Addressing delay values

Comments 45, 89, 91, 92, 137

IEEE P802.3df Task Force

September 2023

167.3.1 Delay constraints

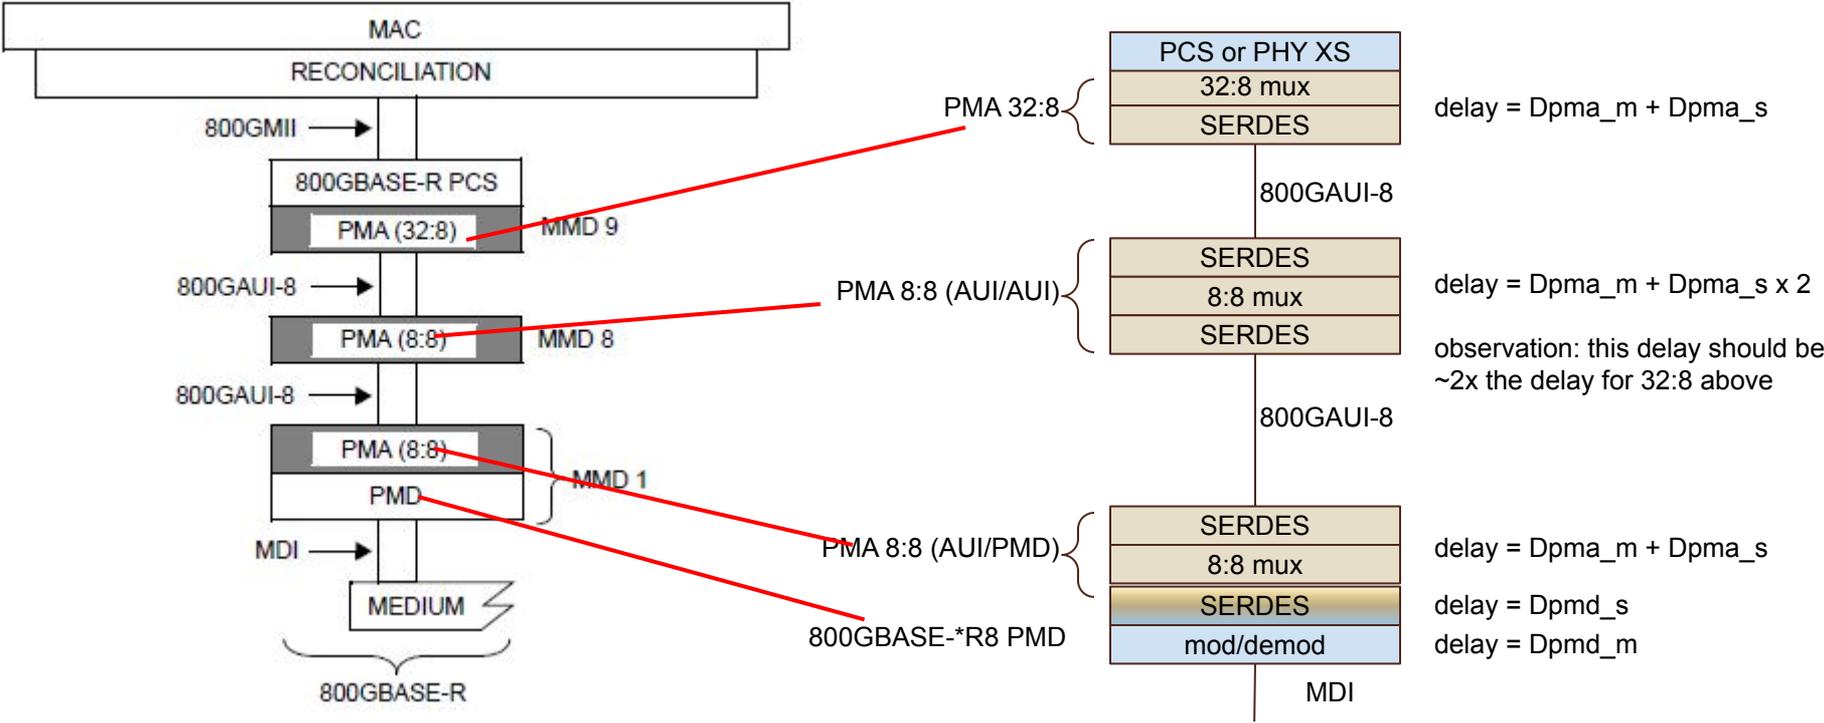
The PMD delay constraint for 800G optical PMDs should be the same in ns terms to those of similar PMDs at the same signaling rate with fewer lanes (viz., 20.48 ns rather than 40.96 ns).

To allow the total delay for 800G modules as has been adopted in response to comment #82 against D2.0, an extra delay of 20.48 ns can be allocated to the PMA instead, to create the same total delay of 87.04 ns (for PMD+PMA). Note that the delay could be added only for the PMA(8:8), but currently, there is no distinction between PMA types.

The delay allowance for an 8:8 PMA is too low, and the allowance for an optical PMD is out of step with other optical PMDs. (The allowance for CR or KR PMD+AN may be wrong too, but it doesn't matter much as they are always combined with PMAs.) See dawe_3df_01a_2307 Module and PMA delay limits, and other comments on delay

Change "800GBASE-R PMA" to "32:8 or 8:32 800GBASE-R PMA". Add a row "8:8 800GBASE-R PMA, 73,728 BT, 144 PQ, 92.16 ns (exactly twice that for the 32:8 or 8:32 PMA). Revert the VR8, SR8, DR8 and DR8-2 PMD allowances to 16,384 BT, 32 PQ, 20.48 ns.

Sublayer	Maximum (bit time) ^[1]	Maximum (pause_quanta) ^[2]	Maximum (ns)	Notes ^[3]
800G MAC, RS, and MAC Control	196 608	384	245.76	See 170.1.4.
800GBASE-R PCS or 800GXS ^[4]	640 000	1250	800	See 172.5.
800GBASE-R PMA	36 864	72	46.08	See 173.5.4.
800GBASE-R PMA 32:8 or 8:32	36 864	72	46.08	See 173.5.4.
800GBASE-R PMA 8:8	72 728	144	92.16	See 173.5.4.
800GBASE-KR8 PMD	32 768	64	40.96	Includes allocation of 14 ns for one direction through backplane medium. See 163.5.
800GBASE-CR8 PMD	32 768	64	40.96	Includes allocation of 14 ns for one direction through cable medium. See 162.5.
800GBASE-VR8 PMD	32 768 16 384	64 32	40.96 20.48	Includes 2 m of fiber. See 167.3.1.
800GBASE-SR8 PMD	32 768 16 384	64 32	40.96 20.48	Includes 2 m of fiber. See 167.3.1.
800GBASE-DR8 PMD	32 768 16 384	64 32	40.96 20.48	Includes 2 m of fiber. See 124.3.1.

Sublayer	Maximum (bit time) ^[1]	Maximum (pause_quanta) ^[2]	Maximum (ns)	Notes ^[3]
800G MAC, RS, and MAC Control	196 608	384	245.76	See 170.1.4.
800GBASE-R PCS or 800GXS ^[4]	640 000	1250	800	See 172.5.
800GBASE-R PMA	36 864	72	46.08	See 173.5.4.
800GBASE-R PMA 32:8 or 8:32	40 960	80	51.2	See 173.5.4.
800GBASE-R PMA 8:8	81 920	160	102.4	See 173.5.4.
800GBASE-KR8 PMD	32 768	64	40.96	Includes allocation of 14 ns for one direction through backplane medium. See 163.5.
800GBASE-CR8 PMD	32 768	64	40.96	Includes allocation of 14 ns for one direction through cable medium. See 162.5.
800GBASE-VR8 PMD	32 768 16 384	64 32	40.96 20.48	Includes 2 m of fiber. See 167.3.1.
800GBASE-SR8 PMD	32 768 16 384	64 32	40.96 20.48	Includes 2 m of fiber. See 167.3.1.
800GBASE-DR8 PMD	32 768 16 384	64 32	40.96 20.48	Includes 2 m of fiber. See 124.3.1.
